CHELAN COUNTY NATURAL RESOURCE DEPARTMENT
COIC IMPROVEMENT PROJECT – DELIVERY PIPELINES

ADDENDUM NO. 3

APPENDIX C: REVISED DRAWING C-26

1 TYPICAL SERVICE CONNECTION DETAILS
SCALE: NOT TO SCALE

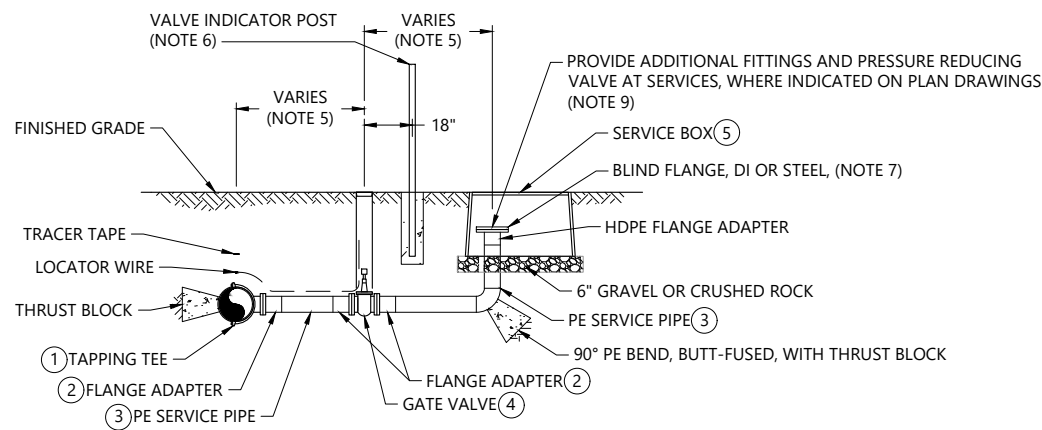
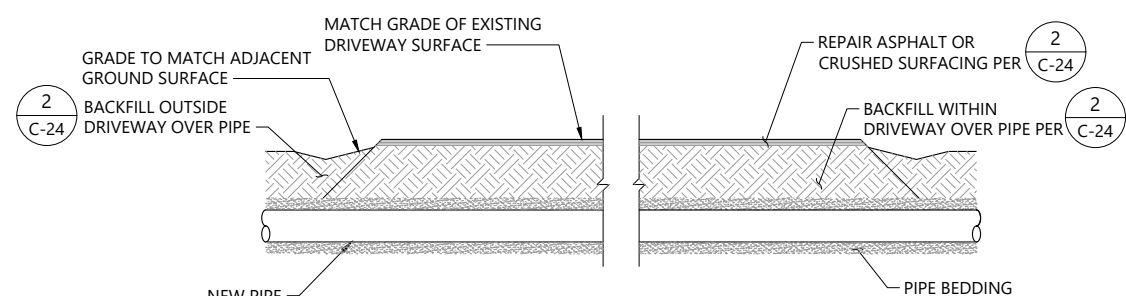
Detail 1 – Typical Service Connection Details, on Drawing C-26 (attached as Appendix C) is revised to correct the type of valve connections intended for 3-inch and 4-inch service connection gate valves. Those valves should be flanged valves. A note was also added to clarify the intended configuration of service connections where multiple service connections branch off of a single pipe connected to a lateral or main pipeline.

- AT ALL SERVICE CONNECTIONS 3" AND LARGER (TYPE C AND TYPE D) LOCATED AT AN ELEVATION OF LESS THAN 1,160 FEET, PROVIDE A 90° D.I. BEND, FL X FL, AND A PRESSURE REDUCING VALVE, FL X FL, PER SPECIFICATIONS.

10. WHERE MULTIPLE SERVICE CONNECTIONS BRANCH OFF A SINGLE PIPE CONNECTED TO THE LATERAL OR MAIN PIPELINE, THE FOLLOWING SHALL APPLY:
 A) A SADDLE TAP OR TAPPING TEE SHALL BE INSTALLED ON THE LATERAL OR MAIN PIPELINE, AS LISTED IN THE TURNOUT SIZES AND MATERIALS TABLE, WITH AN OUTLET EQUAL IN SIZE TO THE PIPE THAT TEES OFF THE LATERAL OR MAIN PIPELINE.
 B) THE PIPE SHALL BE SLEEVED IF IT CROSSES UNDER A PAVED ROADWAY.
 C) THE BRANCH WHERE THE PIPE SPLITS INTO MULTIPLE SERVICES MAY BE CREATED USING BUTT-FUSED HDPE FITTINGS, SADDLE TAPS, OR SOME COMBINATION OF THE TWO.
 D) THE MATERIALS FOR EACH SERVICE LINE BEYOND THE BRANCH SHALL BE AS INDICATED IN THE TURNOUT SIZES AND MATERIALS TABLE FOR THE APPLICABLE SIZE OF TURNOUT.
